BLACKETT
MAGUIRE+
GOLDSMITH

BCA ASSESSMENT REPORT

9 Roussell Road, Eastern Creek

Revision 1

Figure 1: Perimeter Vehicular Access

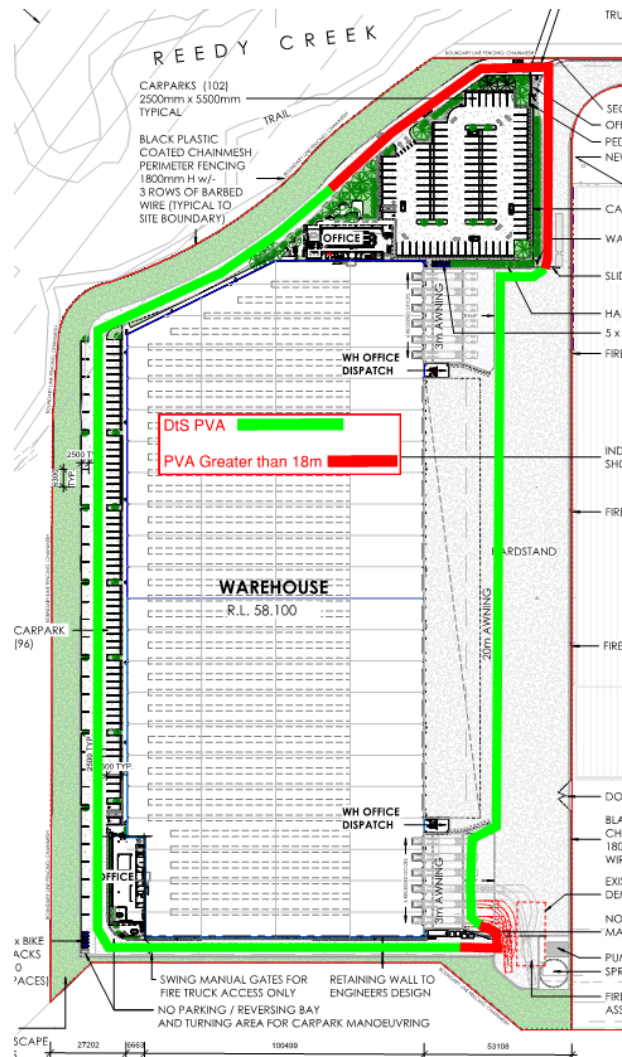
Comments: The proposed building does not comply with the provisions of C2.4 and thus the following non-compliance areas are identified on the site plan that are required to be addressed as a Performance Solution by the Fire Safety Engineer for the development:

Note 1: The furthest part of the vehicular access path is greater than 18m external wall at the North Eastern end of the site around the carpark and South Eastern corner of the site around the recessed docks.

Note 2: The DtS compliant perimeter vehicular access is shown in green in the mark-up above.

Note 3: The driveways providing vehicular perimeter access must be designed with adequate loading capacities to withstand a fire truck and the gradients of the ramps should take into consideration to the FRNSW Policy 4 Vehicular Access Guideline.

Note 4: During and after construction, the existing warehouse to the east will have no vehicular perimeter access on its west side. Gates will therefore need to be installed in the north and south of the hardstand on the proposed development in order to allow vehicular perimeter access to the existing warehouse during and after construction of the proposed warehouse. Compliance is readily achievable in this regard.
